SUBJECT: Donald C. Cook Nuclear Plant Unit 1
Docket No. 50-315
Response to Request for Additional Information Regarding the Reanalysis of Unit 1
Small Break Loss-of-Coolant Accident

Enclosure 1 to AEP:NRC:8046

Figure 8-1 – Loop 1 (Broken Loop) Pump Suction Cross-Over Leg Mixture Level
3.25 inch Break

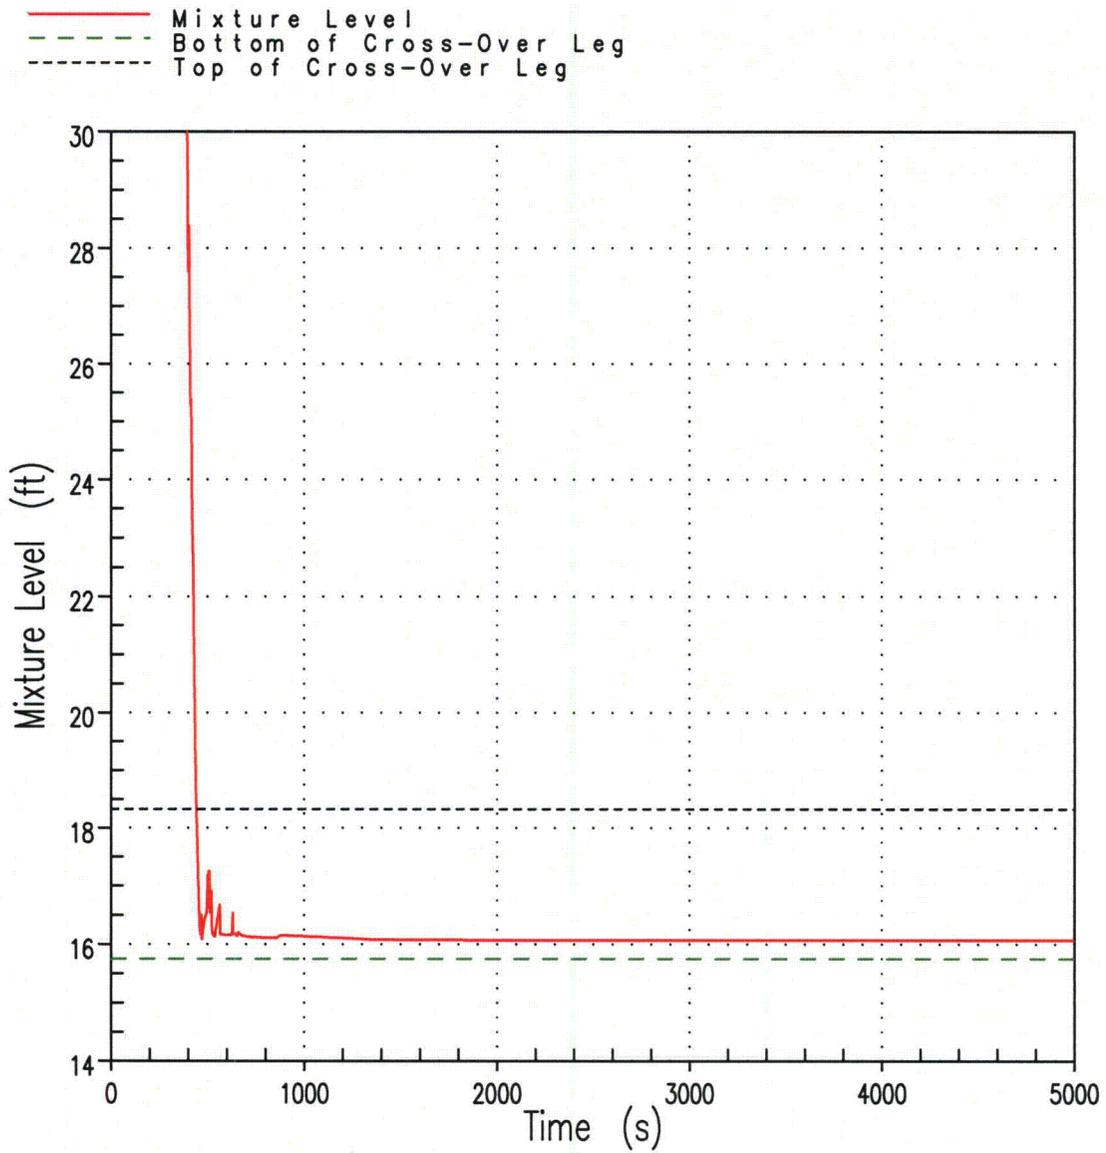
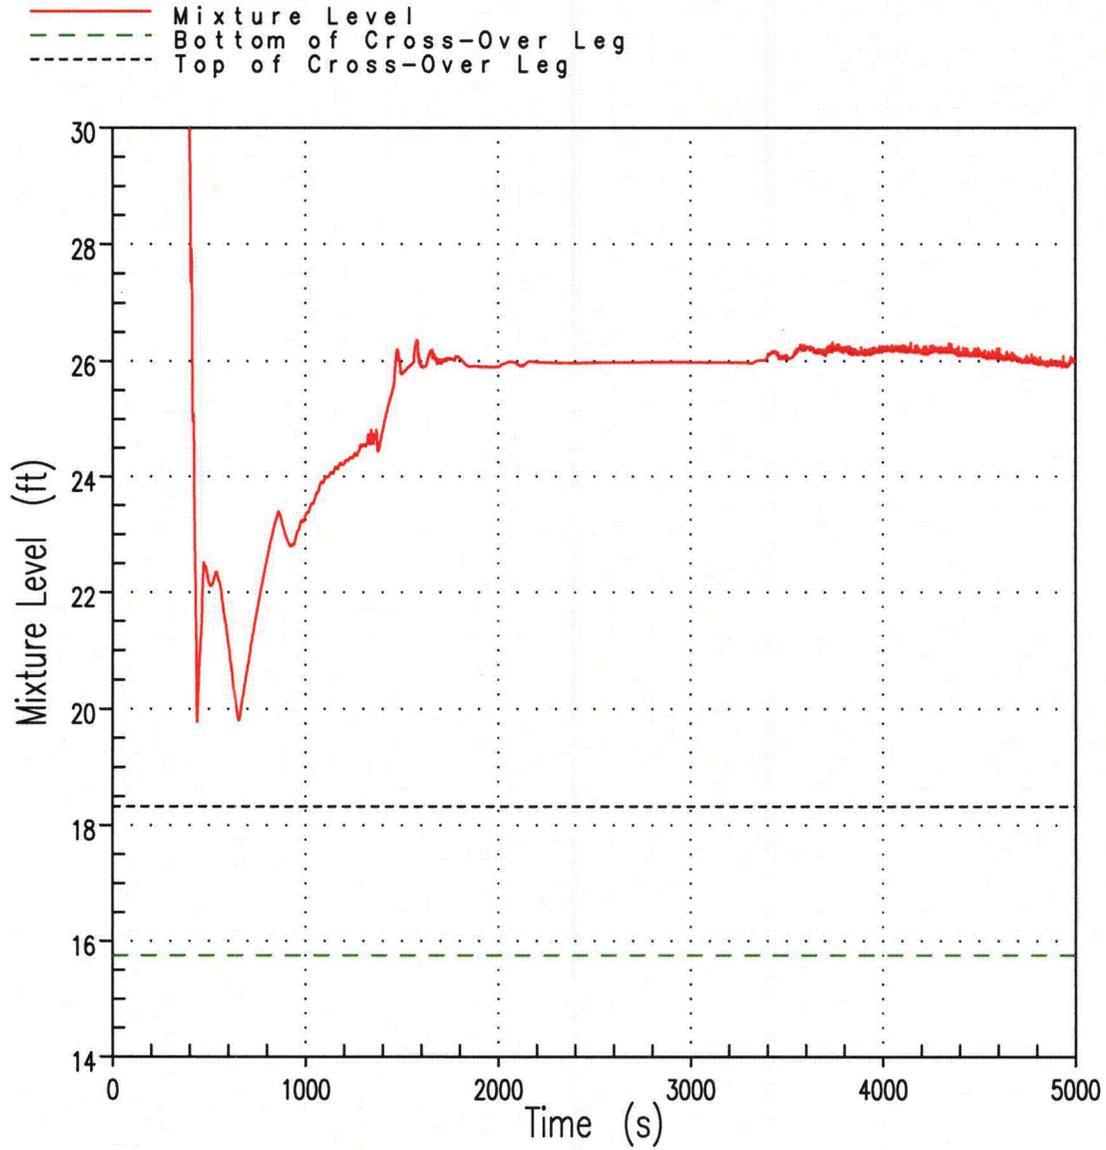
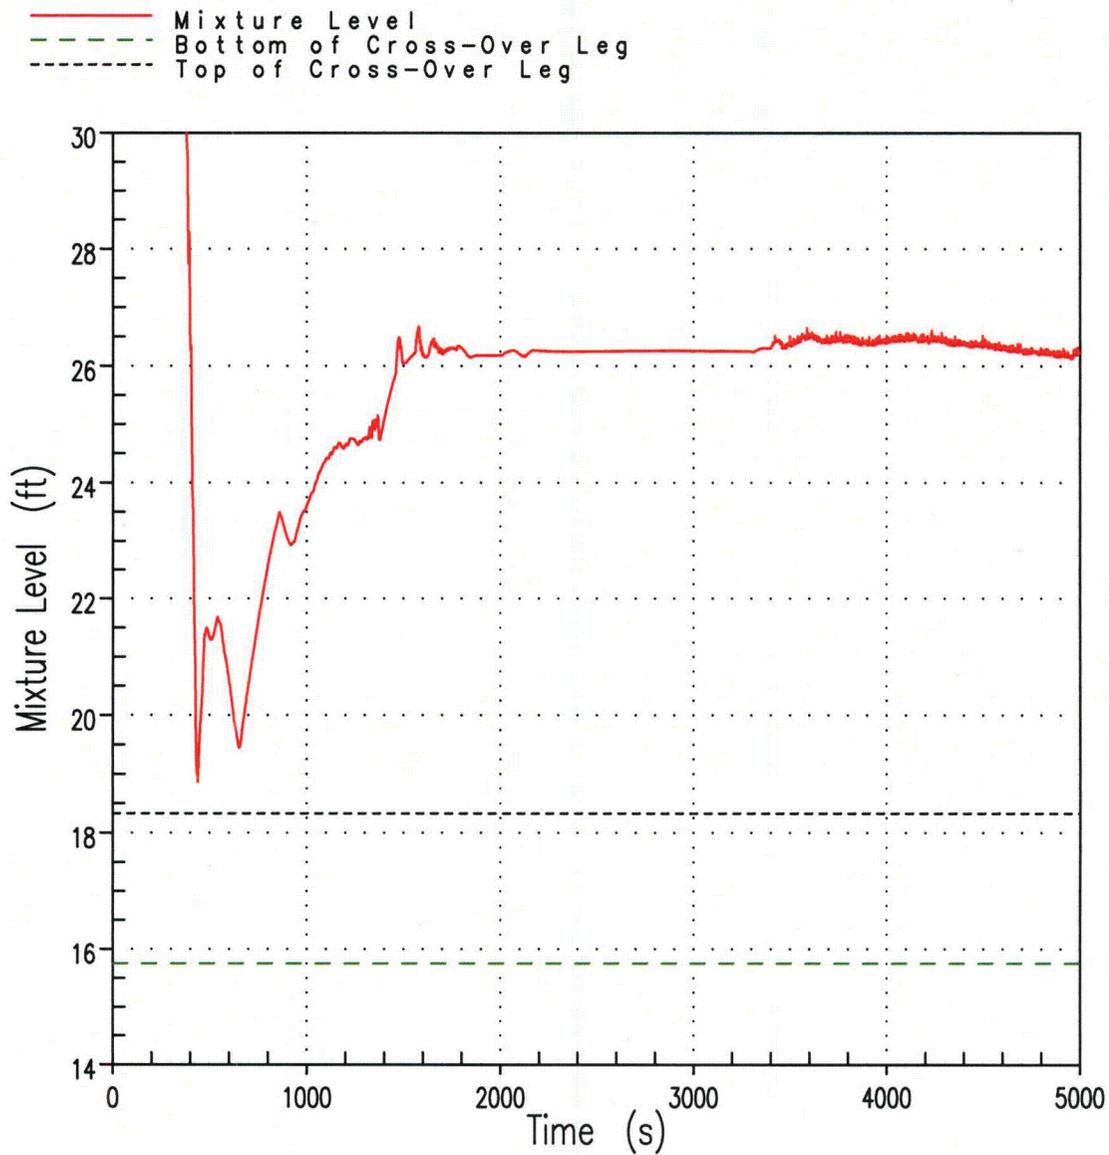
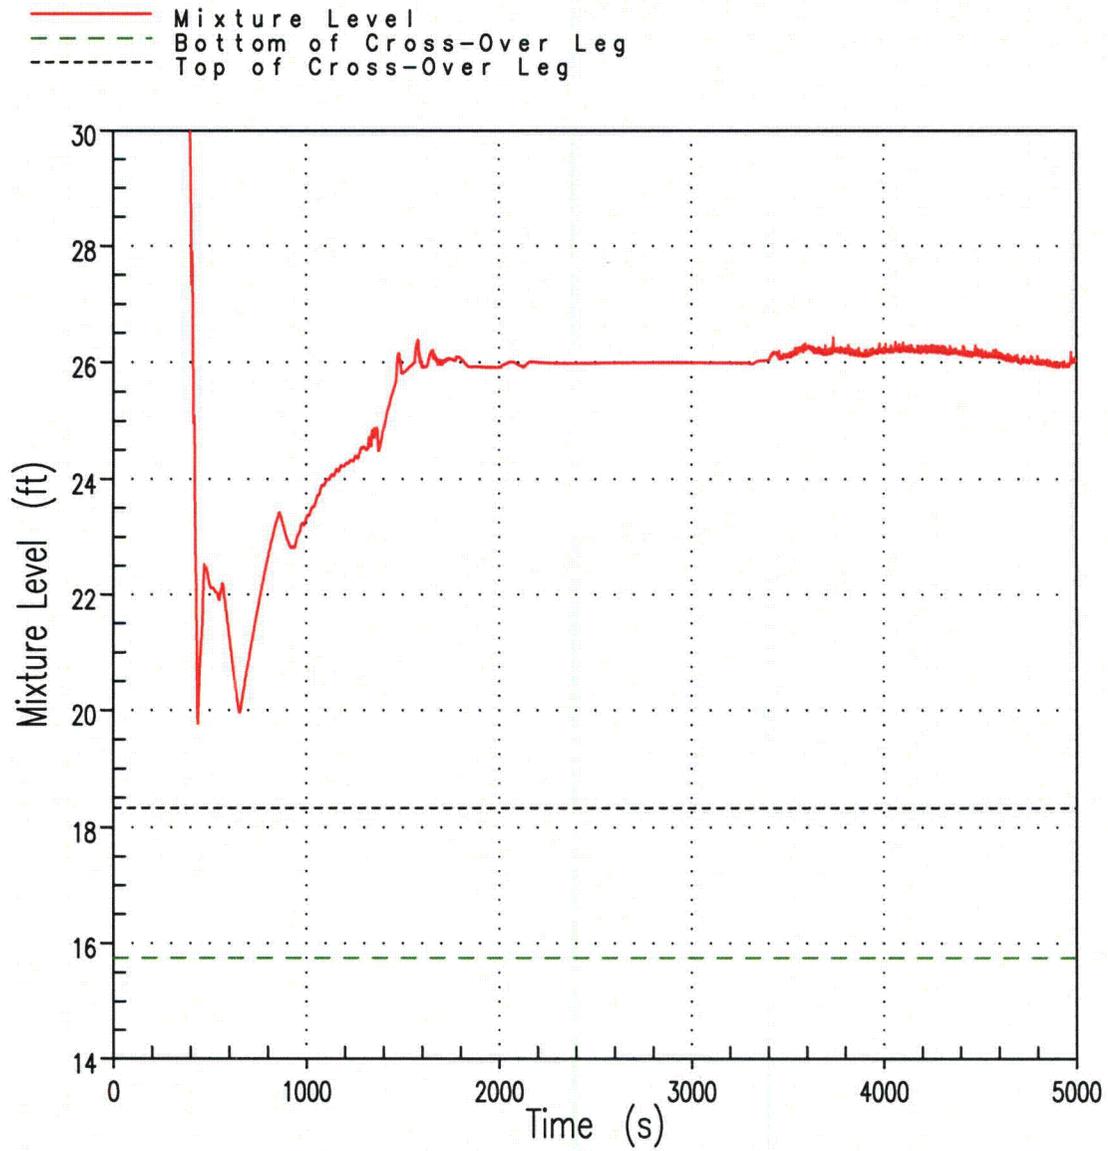
For each break size, please identify the timing for and the location of the loop seals that clear of liquid. Please provide plots of the liquid levels in the vertical sections of the loop seals for the most limiting break.

Loop-seal clearing information was provided with the time sequence of events information, which is presented in Table 6 of the enclosure to Reference 1. The information in Table 6 of Reference 1 includes a footnote describing that "loop-seal clearing is assumed to occur when the steam flow through the broken loop, loop-seal is sustained above 1 pound-mass per second (lbm/s)."

The loop-seal model is addressed in detail (including numerous associated experimental tests and staff audit analyses) in the May 2, 1985, safety evaluation report contained within Reference 7. The analysis methodology includes a restriction that prevents significant amounts of steam flow through the loop-seal in the intact loops. The result is that significant amounts of steam are only allowed to vent from one loop-seal (the broken loop). This assures conservative loop-seal behavior which yields a more severe core mixture level and cladding heat-up transient response during a small break LOCA. This artificial restriction was applied to the CNP Unit 1 analysis consistent with the modeling methodology clarified in Reference 9.

During a telephone conference call between I&M and NRC staff on July 20, 2007, the staff explained that in addition to the Table 6 loop-seal clearing information, the NRC staff would like: a) which loop-seals clear first and b) how many loop-seals are assumed to have cleared. NRC staff explained that the requested information is for the purpose of performing confirmatory checks of the method using the NRC staff's computer codes. As stated by I&M personnel during the July 20th call, the level of detail requested by NRC staff from the approved Westinghouse NOTRUMP model is not normally provided in an analysis report. The loop-seal clearing model is part of the NRC-approved NOTRUMP analysis methodology. However, I&M is providing the following additional information from Westinghouse concerning timing for, and the location of, the loop-seals that clear of liquid for each break size; as presented in Table 8-1. Figures 8-1 through 8-4 present the mixture level in the vertical section of the loop-seal of each of the four loops for the most limiting break (3.25-inch break case). Enclosures 2 and 3 provide the table and figures associated with this response.
